CONVAIR

COMMERCIAL CHANGE PROPOSAL

SPEC NO.: ZD- 22-003

CUSTOMER: Delta Air Lines Inc.

Enclosure to CCP No. 154A

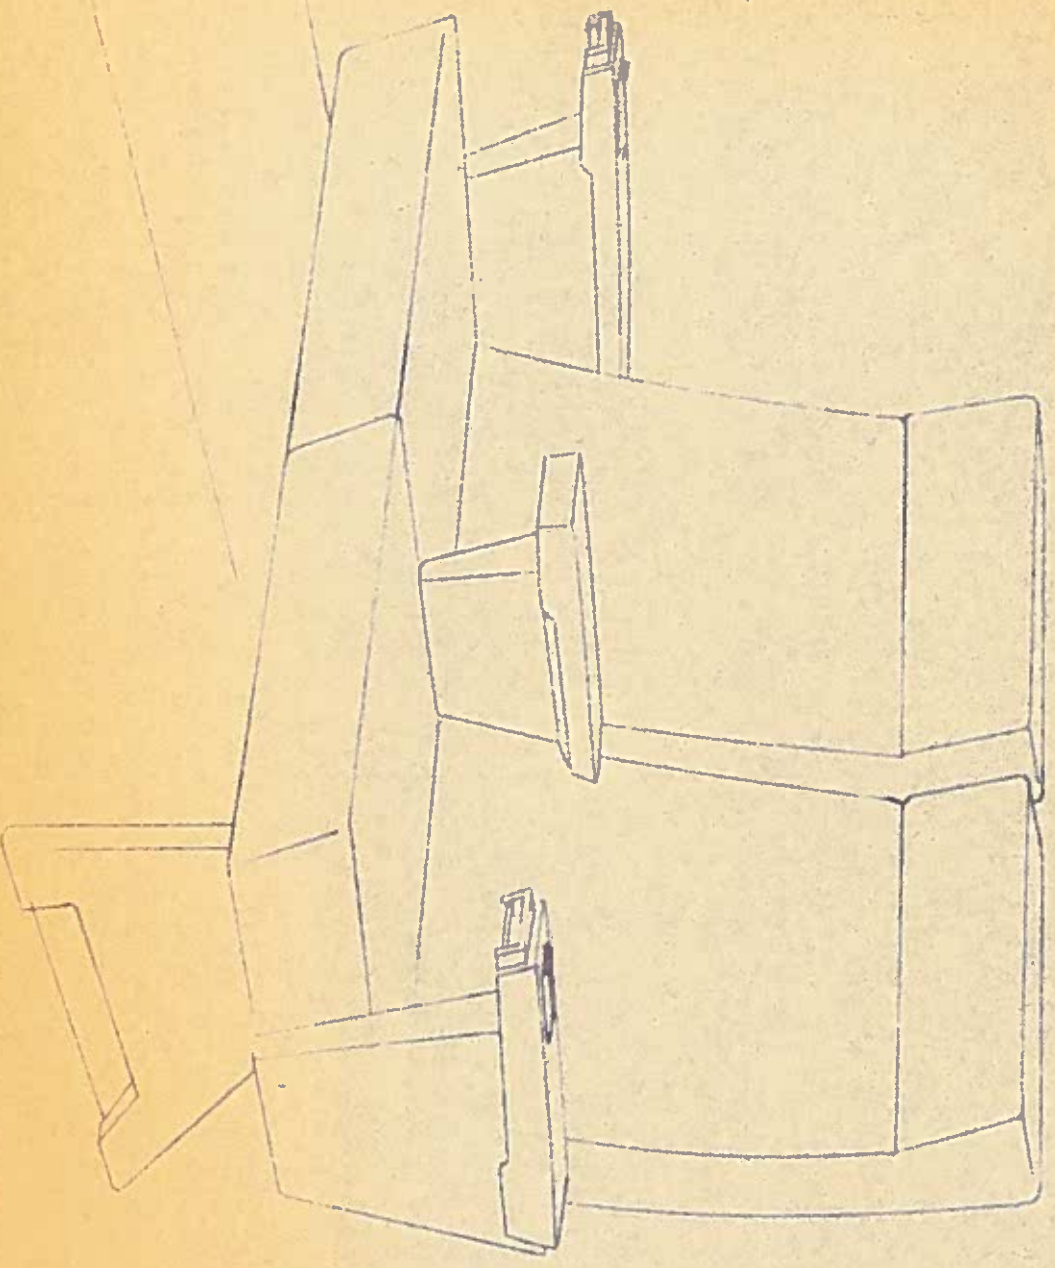
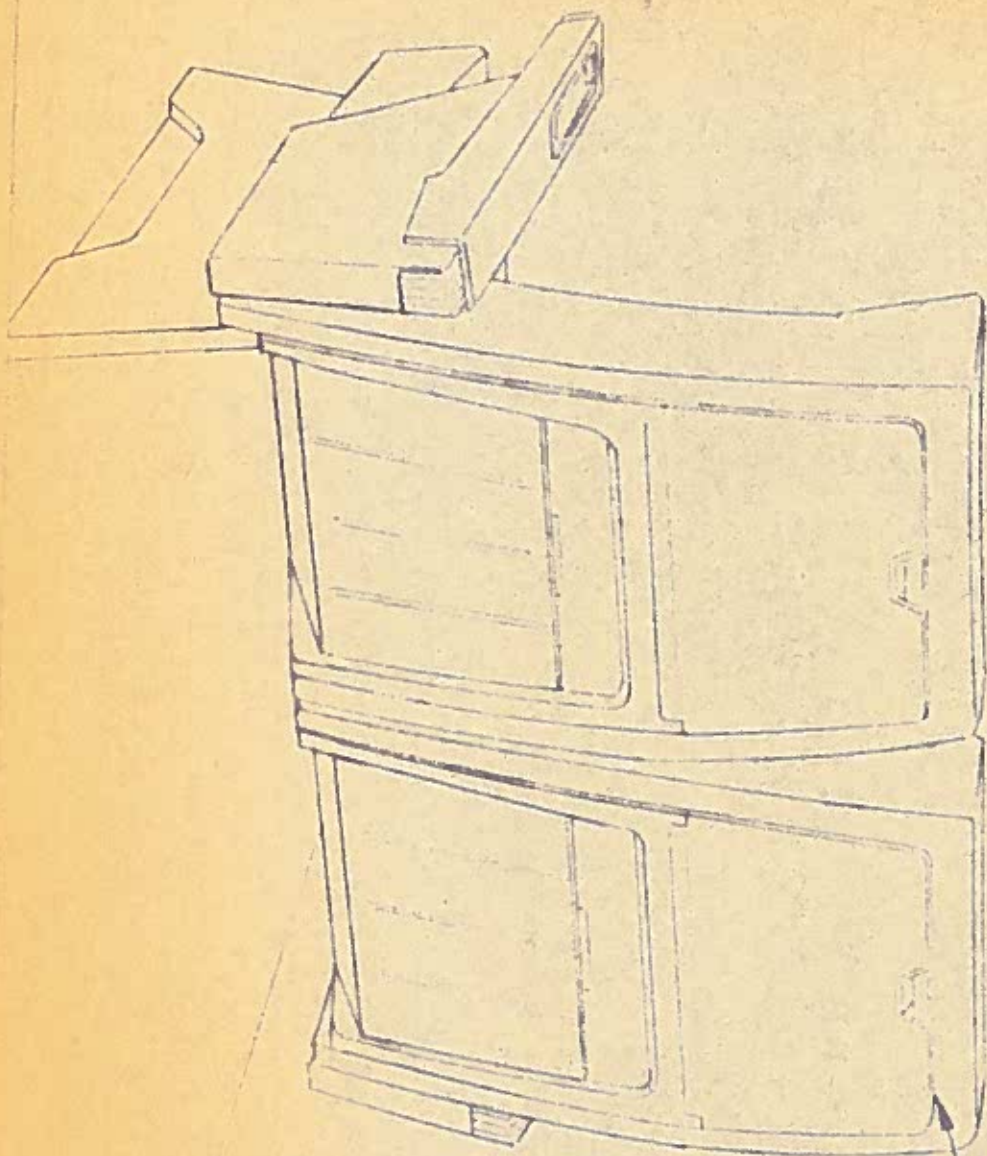
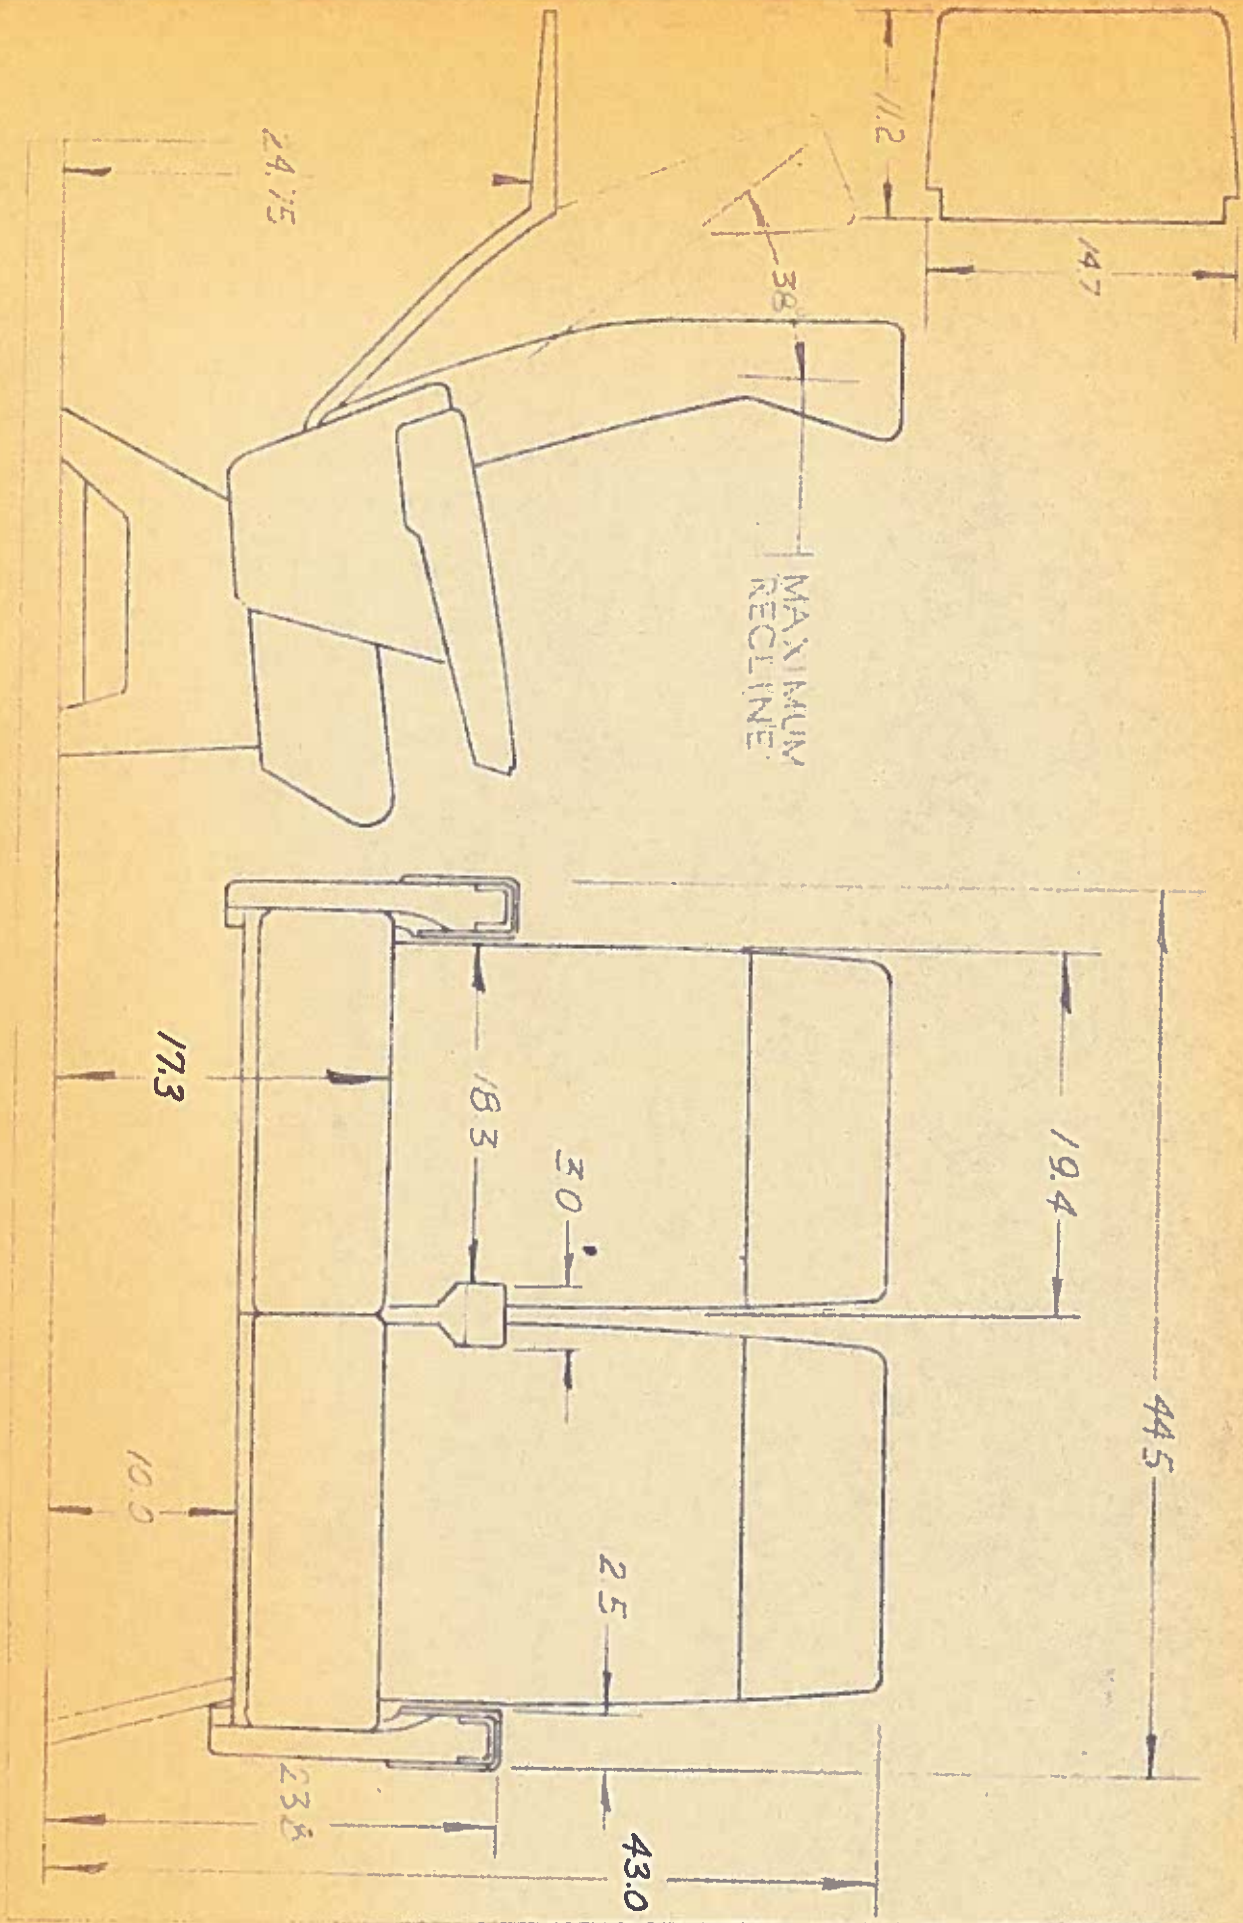
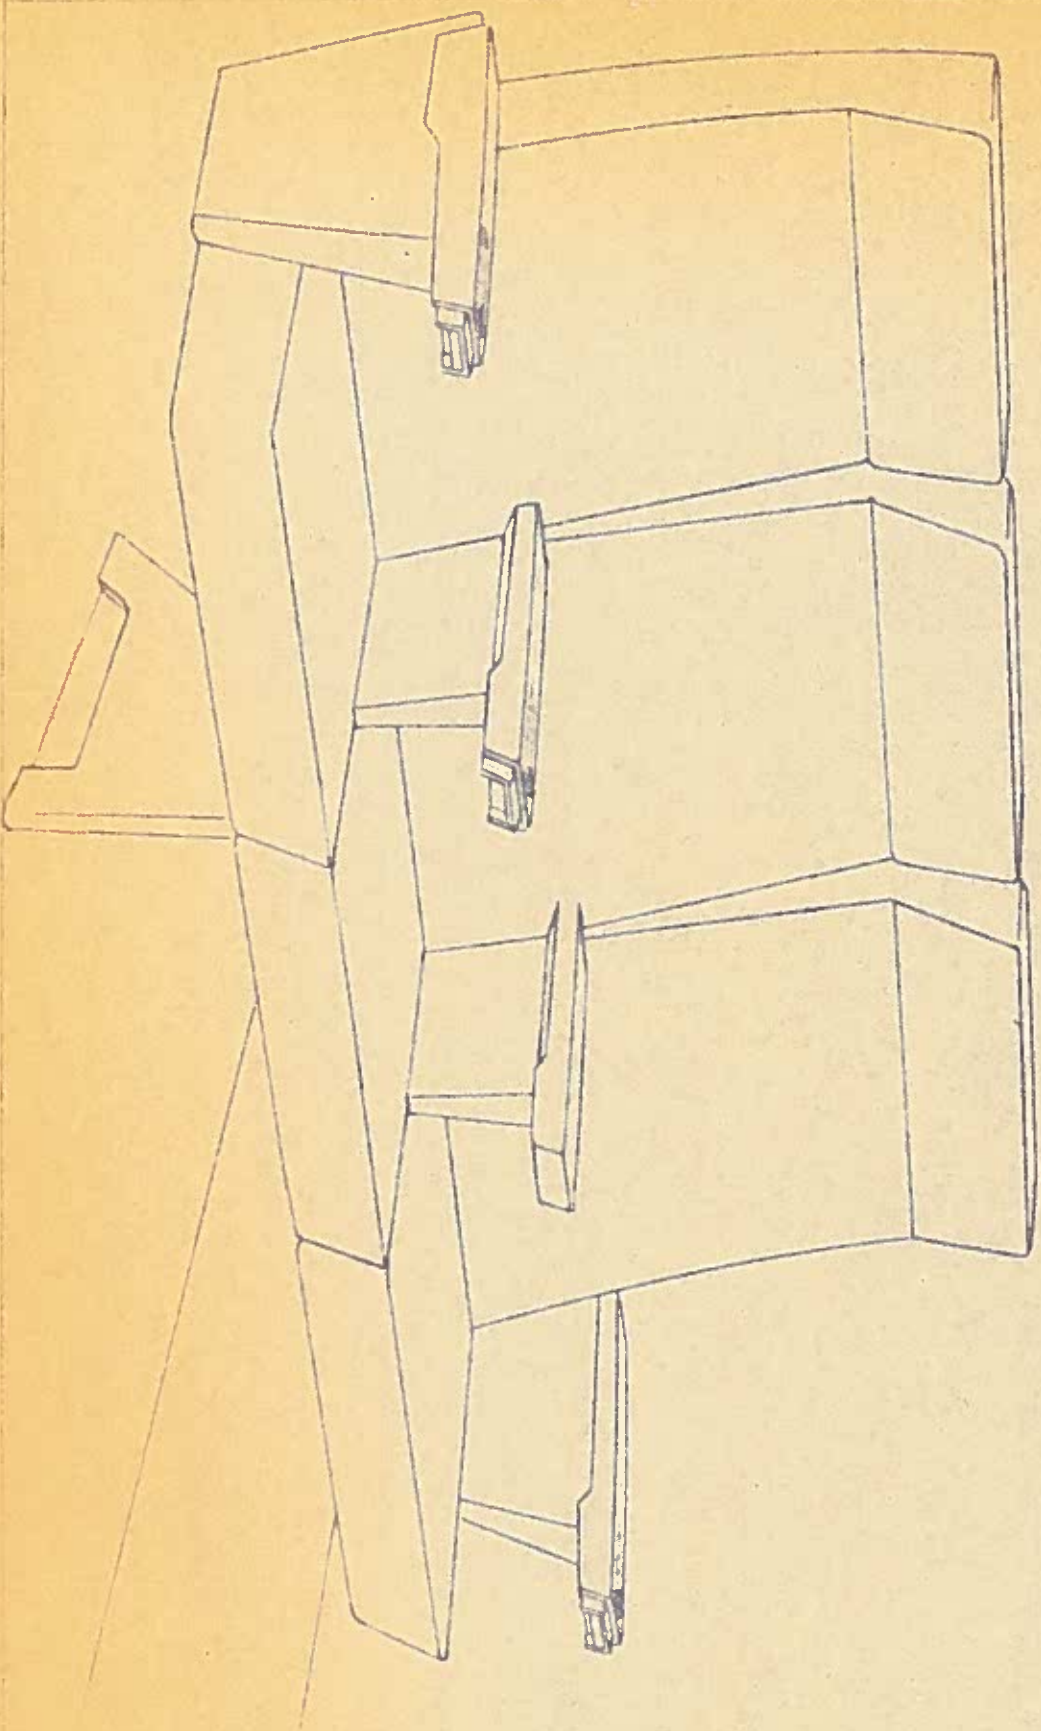
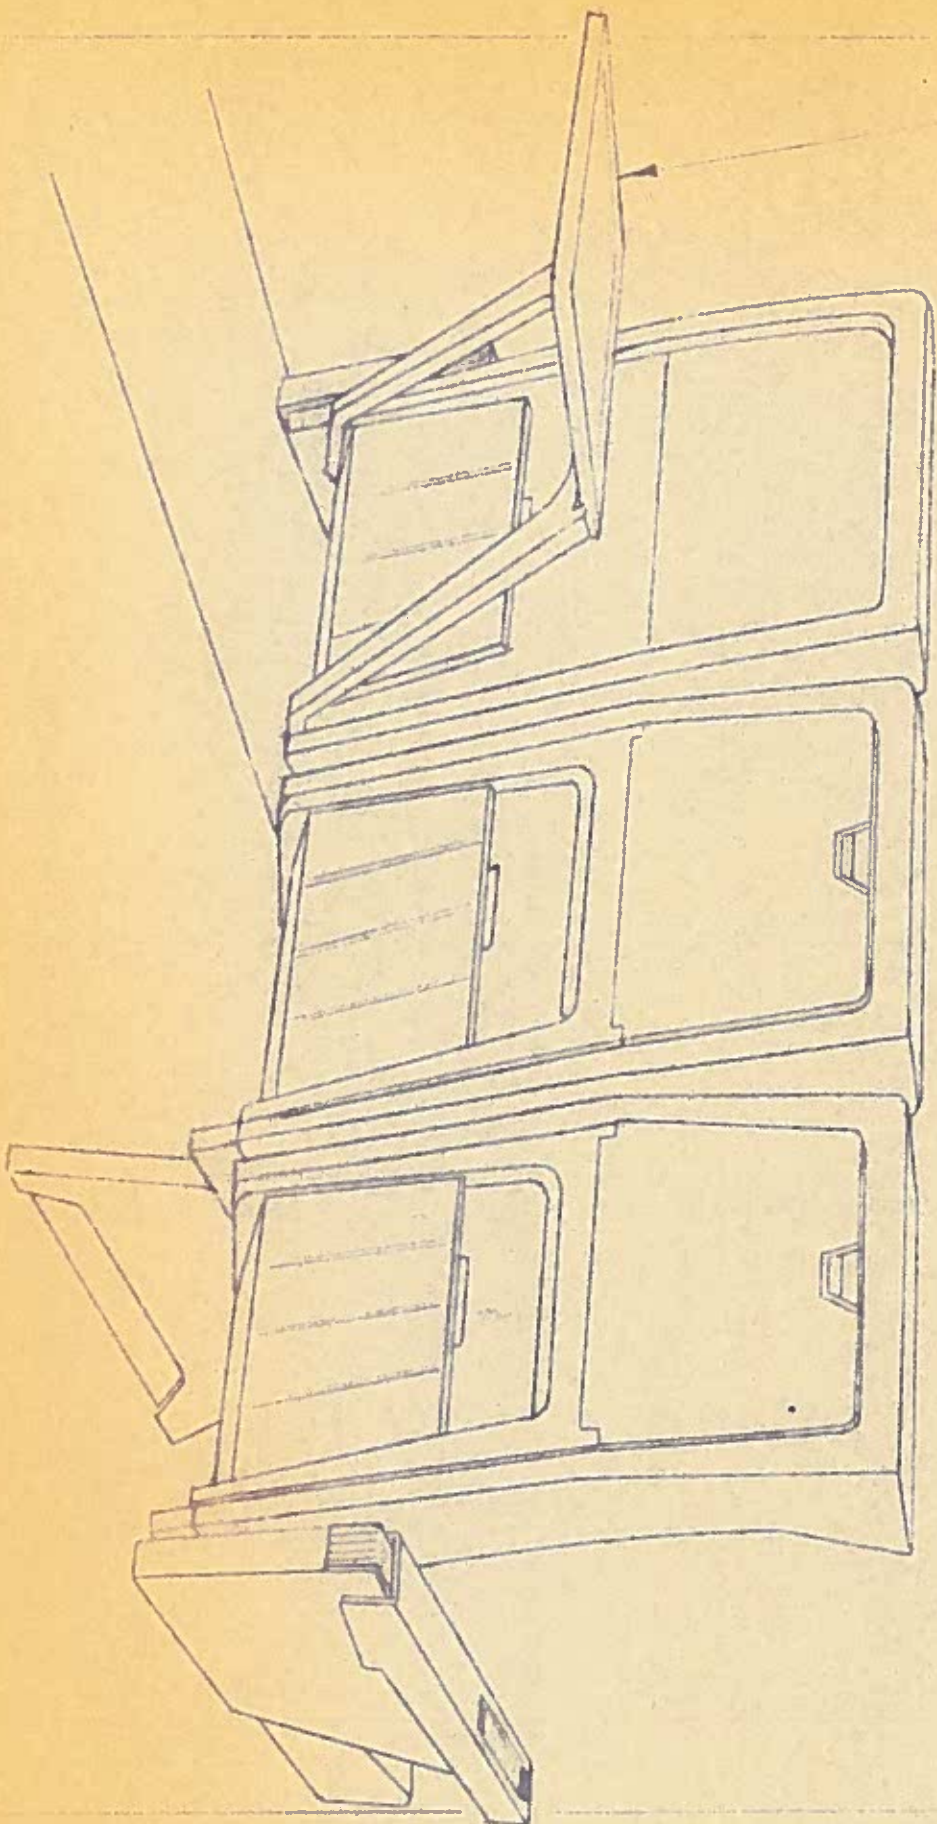
No mock-up or prototype coach seats have been included in this proposal.

Equipment interchangeability for standard seats, as covered in CCP No. 138, is also applicable to coach seats.

Item "A" in paragraph 3.19.1.1.6.2 of this proposal, will provide five plug-in trays for first six rows of Customer order per airplane. Five additional plug-in trays will be provided for 18 or more coach seat rows per airplane. Receptacles for plug-in trays shall be provided as loose equipment on all coach seats not having receptacles installed.

The following parameters shall be used in the coach seat design:

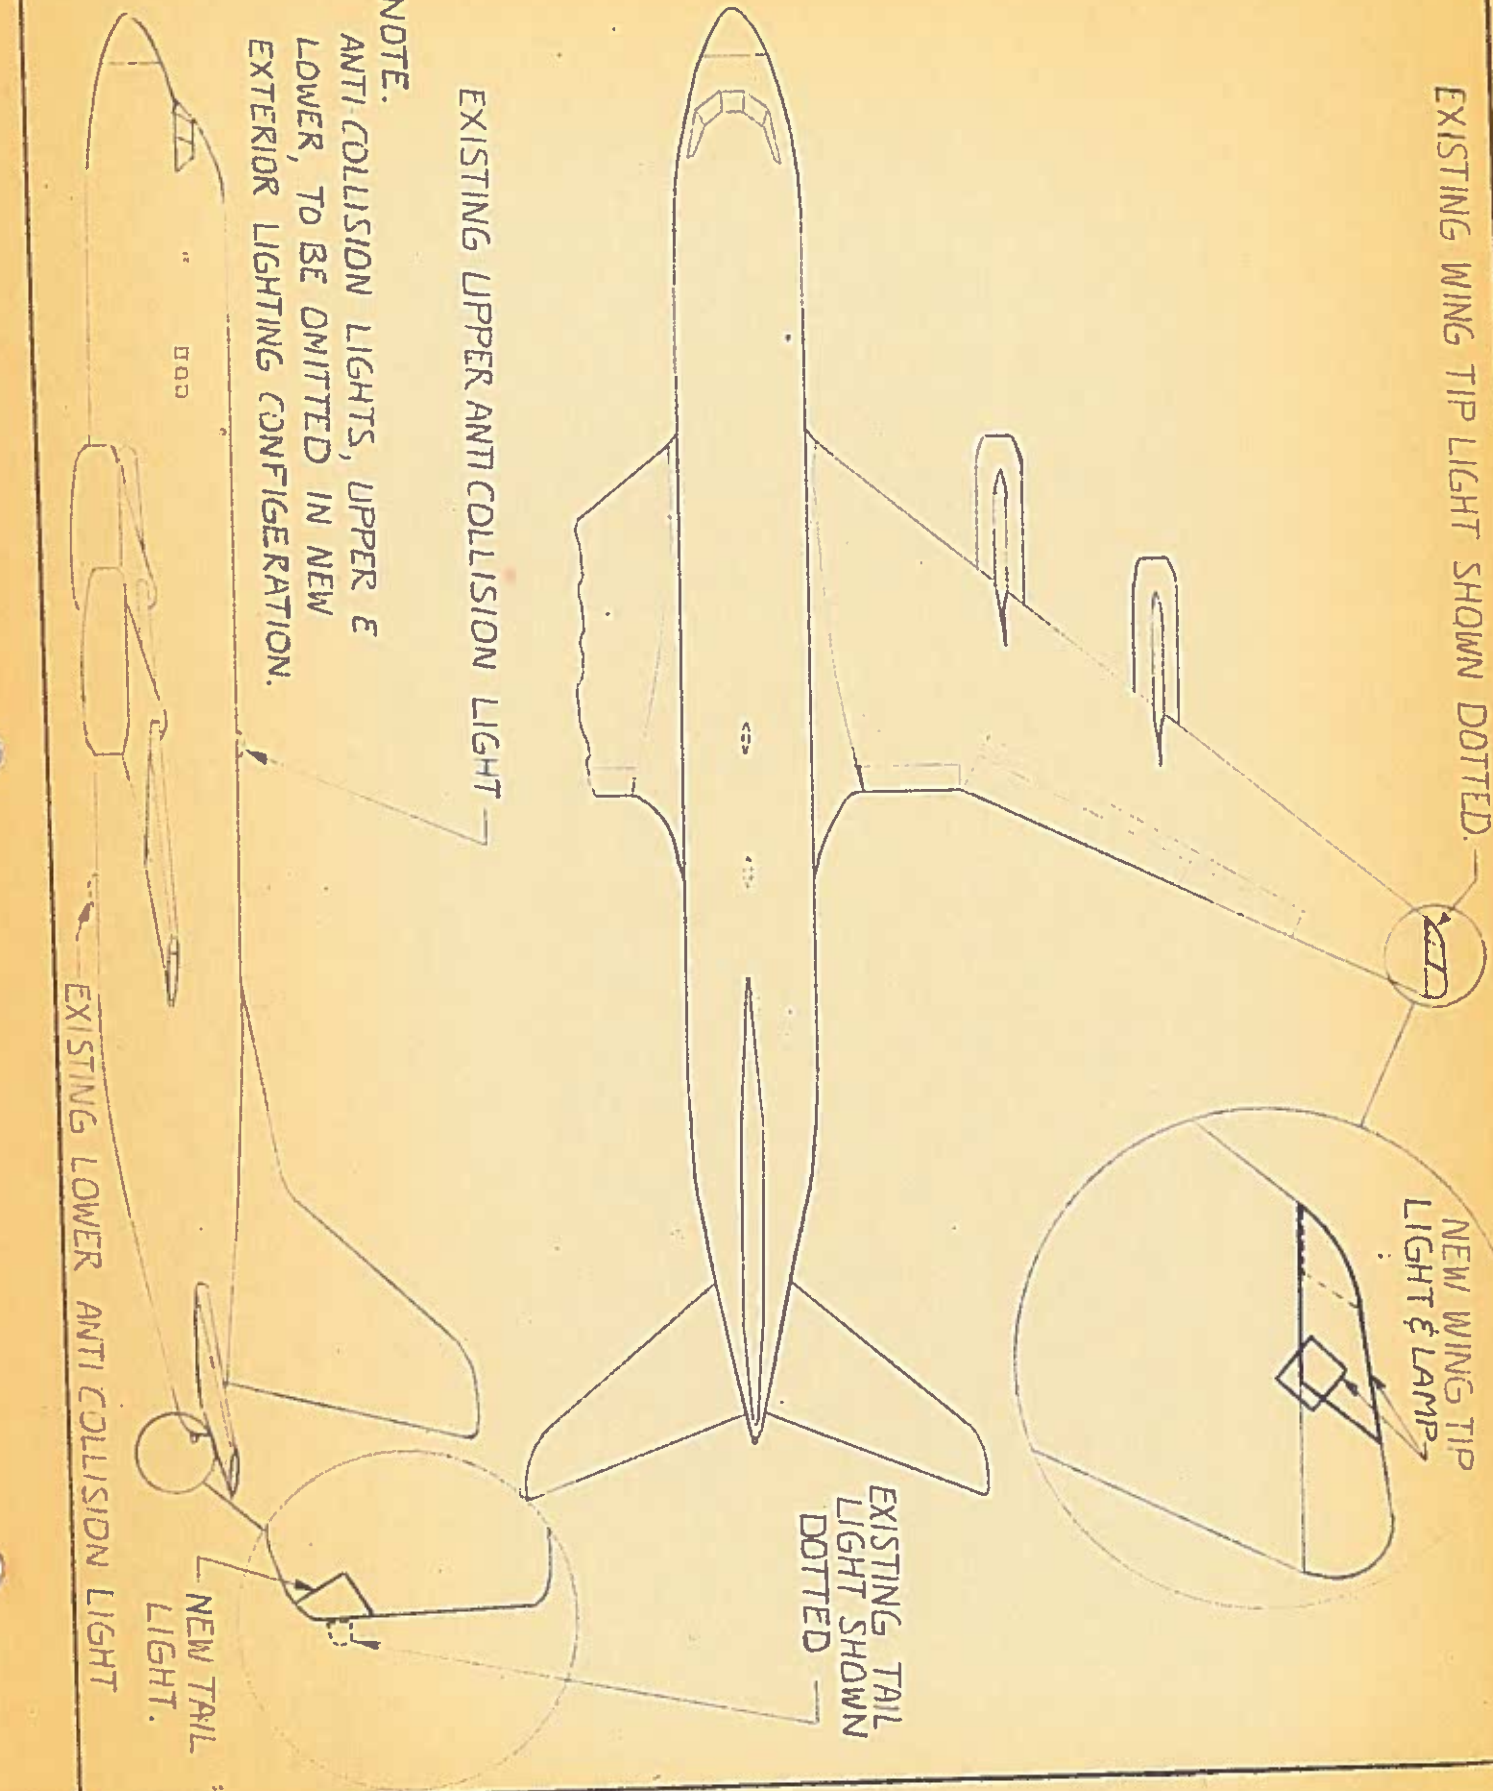
EXISTING TAIL
LIGHT SHOWN
DOTTED

EXISTING UPPER ANTI COLLISION LIGHT

NOTE.

ANTI COLLISION LIGHTS, UPPER &
LOWER, TO BE OMITTED IN NEW
EXTERIOR LIGHTING CONFIGERATION.
